UNITED STATES PATENT AND TRADEMARK OFFICE

| APPLICATION NO. | FILING DATE | FIRST NAMED INVENTOR | ATTORNEY DOCKET NO. | CONFIRMATION NO. |
|-----------------|-------------|----------------------|-----------------------|------------------|
| 10/642,406 | 08/15/2003 | Richard L. Quick | R0367-03700 | 1491 |

| Office Action Summary | Application No. | Applicant(s) | |

DETAILED ACTION

Fig. 5

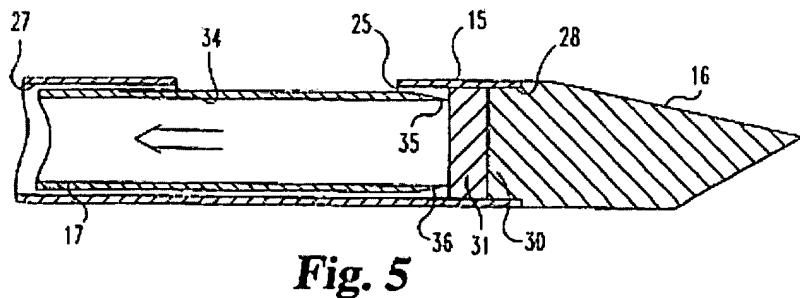
In regard to claim 1, 7, 17-20, Miller et al. disclose a tissue biopsy device (10) for accessing and collecting a tissue specimen from a target site within a patient. The biopsy device comprises an elongated probe member (15), which has a proximal end configured to be secured to a drive and an inner lumen (27) extending along a longitudinal axis. Miller et al. describe the probe further having a penetrating distal tip (16) and an aperture (25) proximal to the penetrating distal tip configured to receive tissue from the target site. The Miller et al. device further includes an elongated tissue cutting member (17), which is disposed within the elongated probe member (15), which has at least one tissue cutting edge (35, 36). The at least one cutting edge has a longitudinal orientation at an angle with respect to the longitudinal axis less than 90 degrees (Fig. 5) and engages a tissue cutting edge (35) of the tissue cutting member.

The tissue cutting member (17) has an inner lumen (34), which is configured to be operably connected to at least one drive unit (22). The inner lumen (34) of the tissue cutting member (17) is further configured to access a vacuum source to transport a tissue specimen through the inner

lumen (34) to a tissue collector (55) in fluid communication with the inner lumen. The aperture (25) of the probe (15) has at least one longitudinally oriented tissue cutting edge, which engages a tissue cutting edge (35) of the beveled tip of the tissue cutting member (17). The tissue cutting edge (35) of the tissue cutting member (17) has a tissue cutting angle over a substantial part of its length with respect to the tissue cutting edge of the aperture of about 30 to about 75 degrees (col. 19, lines 15-47).
